# **DART SERVICE INSTRUCTION**

TO AMEND INSTALLATION INSTRUCTIONS  
IIN-D412-698 REV. E OR EARLIER AND INSTRUCTIONS FOR  
CONTINUED AIRWORTHINESS ICA-D412-698 REV. 5 OR EARLIER

| DE APPR.   | <u>MSH</u>  | EXTERIOR DOOR HANDLE<br>KIT UPDATE   | NTS          |

Figure 52-4: Door Handle Kit (Exterior) (ICA-D412-698)  
Figure 3C: Door Handle Kit (Exterior) (IIN-D412-698)

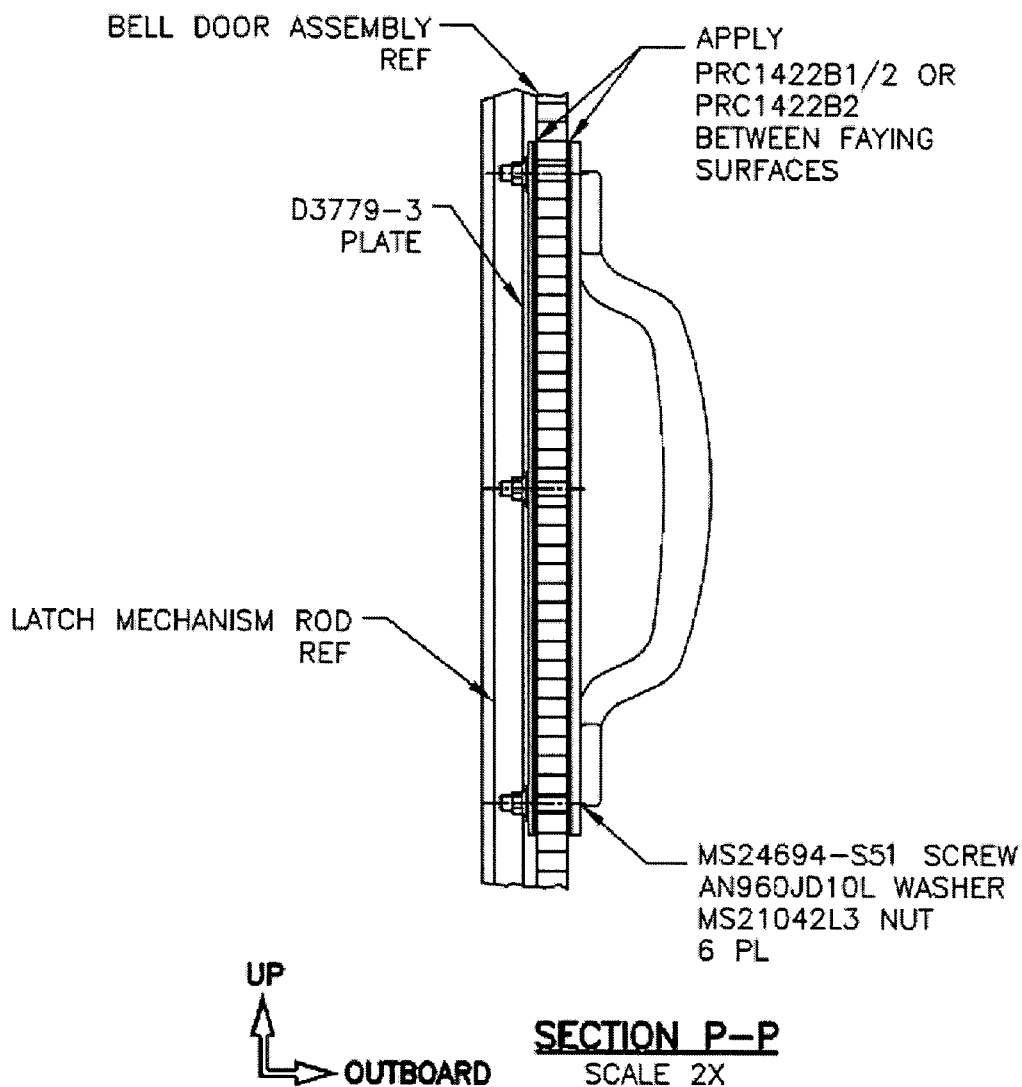
Field installations have shown that the screws used to mount D3779-041 Exterior Door Handles as part of the D412-698-035 Door Handle Kit are too long. The MS24694-S58 screws that were originally provided in the kit should be replaced with MS24694-S51 screws.

**WAS:**

| 12 | MS24694-S58 | SCREW |

**IS:**

| 12 | MS24694-S51 | SCREW |
